**SITE VISIT TO OBSERVE AND VERIFY
PHYSICAL DETAILS**

*Supporting Producers to upgrade Processing Infrastructure to
Obtain GMP*

Technical Report

Submitted to UNIDO – WTO – TSC Project

Figure 5. Sketch of building floor plan (not drawn to scale)

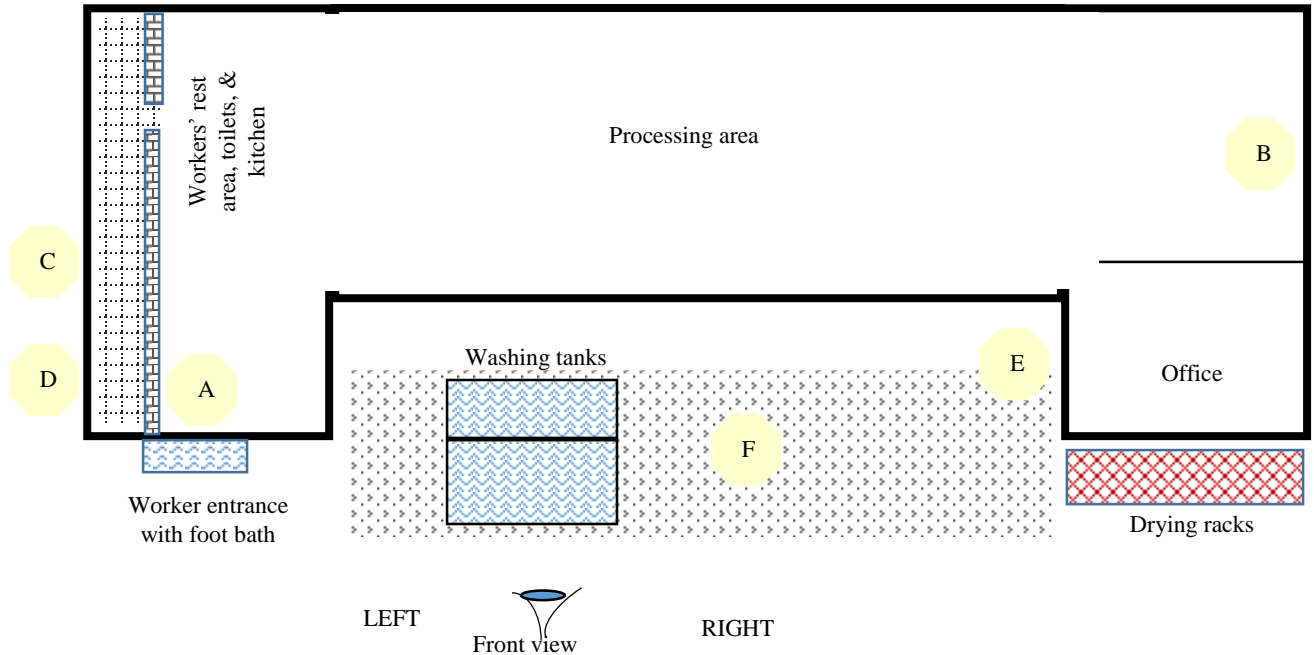
All observations and recommendations are referring to Figure 5.

1. Mark A: Worker entrance. Length of foot bath was not up to standard and should be extended up to a length exceeding two strides of a worker. The entrance was exposed to outside and susceptible to dust; therefore, should fix a plastic curtain.
2. The premise did not have an outlet for removing peeled cinnamon wood and scrapped outer bark. Therefore, it is recommended fix a roller window at point of wall that is mark as B in the sketch.
3. Gap between premise's wall and roof was open thus, susceptible for intrusions of animals into processing area. This gap to be fill-up with plastic mesh.
4. Mark C: There was a door on partition wall between the processing area and workers' rest area. Keeping this door compromises hygiene of processing area thus, it to be filled and sealed. A sealed glass window to be fixed on this partitioning wall.

5. Present entrance to the workers rest rooms, kitchen, and toilet area was not appropriate and thus, to be changed to point mark as D.
6. Some places of existing floor of building were damaged. These place should be repaired.

7. Windows of building are not up to standard. Therefore, require to be changed by fixing louvers and removable mesh replacing grills.
8. Existing brought in cinnamon trees washing tanks were not suitable to proper operations of the factory. These tanks to be revamp and constructed at a suggested place in appropriate size and required finishes (e.g. interior walls tiled with large, gloss finished, glazed marble tiles).

9. Premised did not have a proper utility area to unload and draining excess water of cinnamon tree bundles before taken inside the factory. Recommended to build a utility area and required offloading platform in area marked as F and that to be concreted and cemented according to standard. Furthermore, this area to be demarcated with a half high boundary wall to restrict unauthorized access of workers.

10. Replacement of drying rack from the existing position to a suggested place.
11. The premise did not have a boundary fence. Therefore, suggested to build a half-wall wire-mesh fence surrounding the premise.

12. Required racks, clock hangers, tables, stools, slippers, clocks, caps, drying towels, etc., for workers' and guests' hygiene in entering factory were lacking. These required materials and equipment to be provided.

Figure 10. Sketch of factory layout (not drawn to scale)

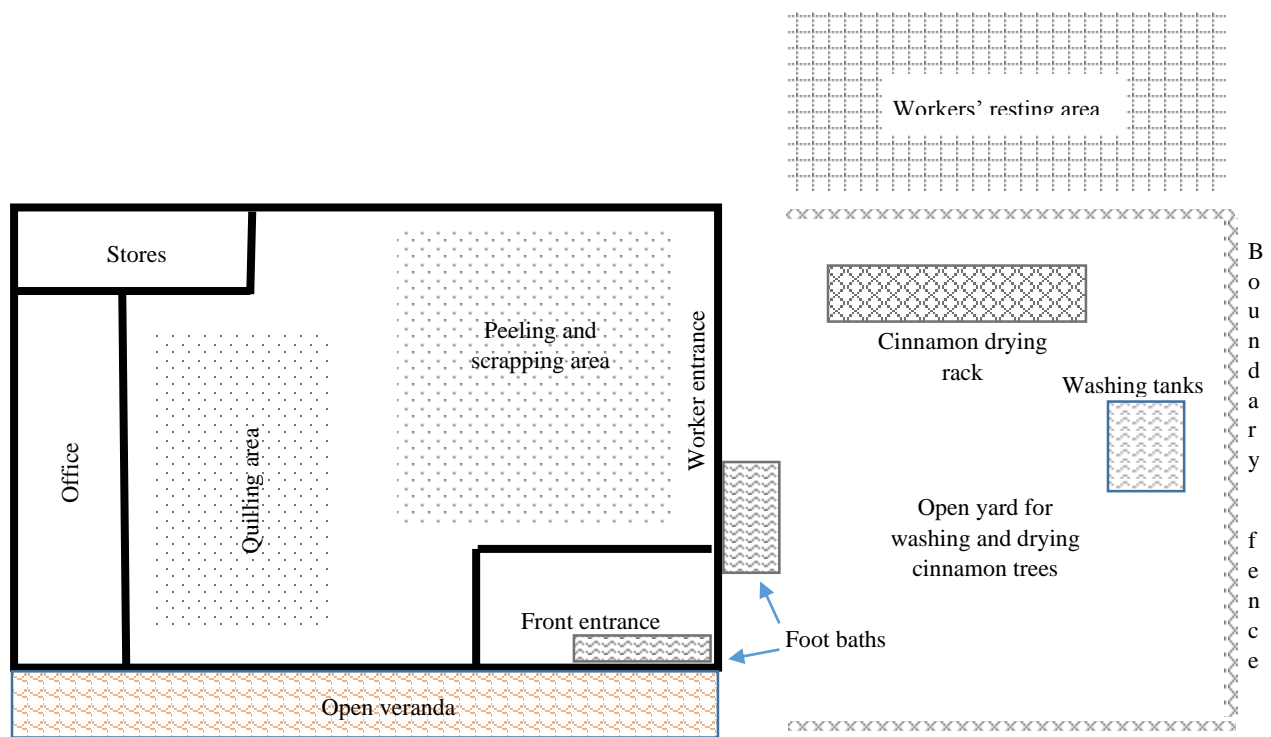
All observations and recommendations are referring to Figure 10.

1. Windows at front entrance area to be changed from wire mesh grills to sliding glass windows with louvers. Fix notice board on front entrance wall. Fix auto door-closure on slashes of door to enter to processing areas from front entrance. Remove wooden slashes, which are on just above foot bath area of front entrance and replace with sealed glasses. Foot bath in front entrance to be modified reducing width by filling up and fixing stainless steel hand rail to guide guests entering to processing areas.

2. Outer door of the entrance to be changed by fixing auto door-closure and top half of the slash fixed with glass and bottom to be fixed with a suitable sheet. Provide rubber and clothes mats at entrance for drying feet after immersing in foot bath.

3. Provide fully covered plastic shades for lightings in processing areas.
4. Replace existing hand operated taps with foot operating taps at all wash basins.

5. Gap between wall brim and roof to be filled with wire mesh to prevent animals entering to processing areas.

6. Required racks, clock hangers, tables, stools, slippers, clocks, caps, drying towels, etc., for workers' and guests' hygiene in entering factory were lacking. These required materials and equipment to be provided.

7. Ceiling of premise to be built by using approved and suitable materials.
8. Colour washing of premise's walls.
9. Use rubber carpets to cover factory floor.

10. Replace center column tiles.
11. Gully of worker cleaning area that is in outside drying area to be repaired.
12. Washing tanks to be chipped off the existing plaster and tiling with large, gloss, and glazed marbles. Floor of outside drying area to be cemented for smooth finish. Boundary wall to be improved by constructing half wall and wire mesh the boundary.

13. Gate to worker resting area from factory to be closed. 21' x 11' area to be demarcated at suggested position and fence with wire mesh and half wall in "L" shape to allow easy handling of cinnamon wood. A new gate (inlet) to be fixed at a suggested position and fix an unloading plat form.

14. Change the existing drying racks according standards.

Figure 12. Factory lay out (a sketch no drawn to scale)

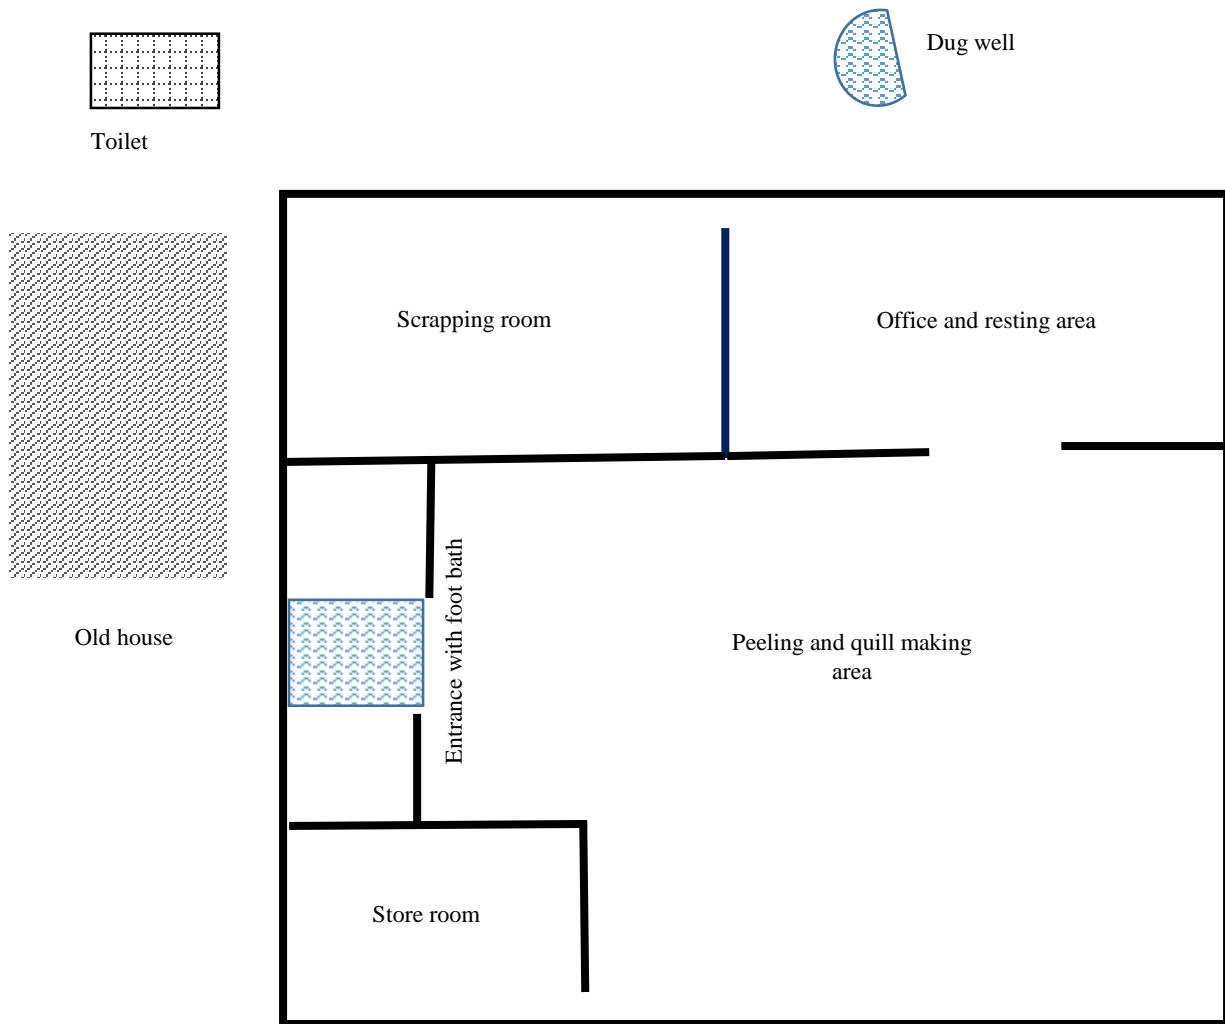
All observations and recommendations are referring to Figure 13.

1. Size of existing scrapping section was not enough for effective work. Expansion of this section of building according to standards is needed.
2. There was no washing tank for factory. Build washing tank at suggested place.
3. Roof was incomplete. Fix gutters, drains, and skirting according to standards for completion.
4. The premise did not have electricity and pipe borne water supply, which support effective and efficient implementation of food safety measures. Obtain electricity to premise and plumbing to standard.
5. There was no boundary fence demarcating premise. Built boundary fence.
6. Door of store room of the factory was lacking a slash. This to be fixed.

7. Required racks, clock hangers, tables, stools, slippers, clocks, caps, drying towels, etc., for workers' and guests' hygiene in entering factory were lacking. These required materials and equipment to be provided.
8. Gap between wall brim and roof to be filled with wire mesh to prevent animals entering to processing areas.
